UNITED STATES PATENT AND TRADEMARK OFFICE

APPLICATION NO.	FILING DATE	FIRST NAMED INVENTOR	ATTORNEY DOCKET NO.	CONFIRMATION NO.
10/604,061	06/24/2003	John Sirowatka	71198-0063	1060

Office Action Summary

DETAILED ACTION

3,423,898

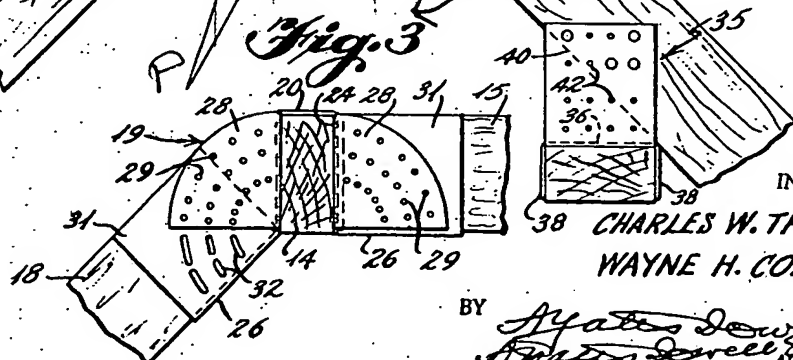
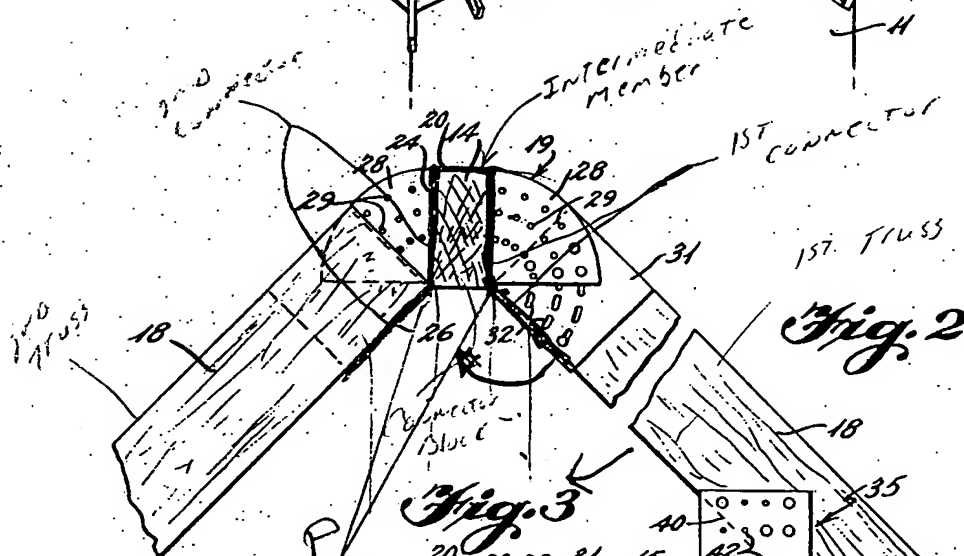
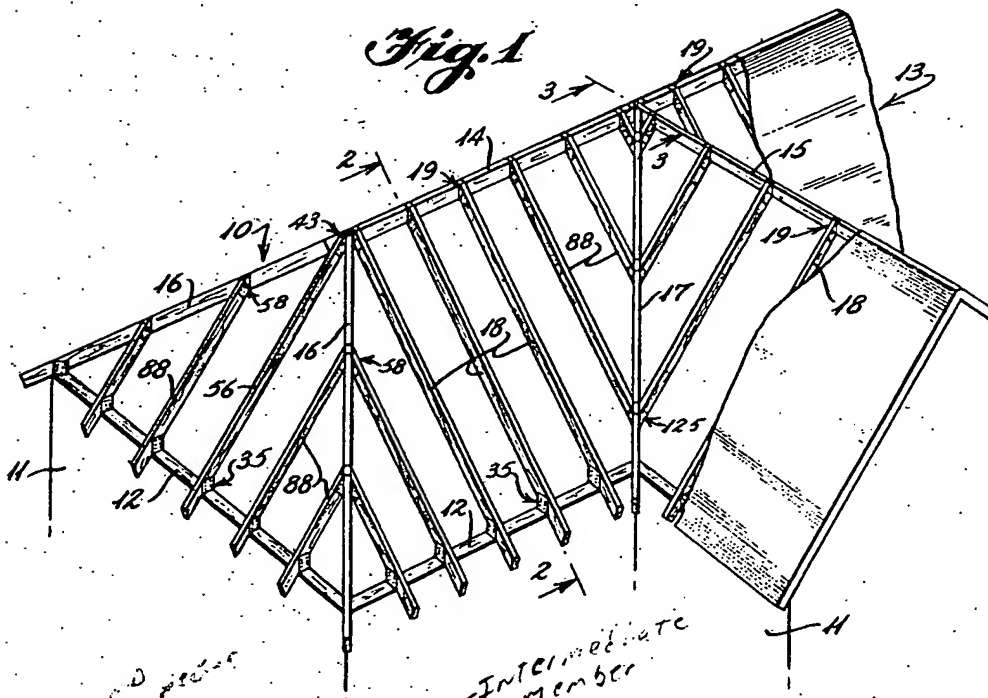
In regard to claims 10, 70: Tracy discloses the claimed invention Fig. 2, a connector and truss assembly including a first and second truss, a connector block 14 having a first end and a second end opposite from the first end, a first and second connector members 28 extending from the first end and second end of connector block 14 which pivotally attached thereto at pivot point P (see attachment) wherein the first connector member 28 is fastened by fastener 22 to the first truss member and second connector member 28 is fastened by fastener 22 to second truss member, the first truss member inherently capable of folding reversely atop of the second truss

member in direction of array (see attachment) about the respective pivotal mountings on the connector block 14.

In regard to claim 71: Tracy discloses the claimed invention Fig. 3, the first trust member has an inner and outer vertical surface 31 and second connector member 28 has outer and inner vertical member, and wherein the inner vertical surface of the first trust member and outer vertical surface of the second connector member 28 come into abutment when the first truss member is moved to a fully unfolded position with respect to the second connector member 28.
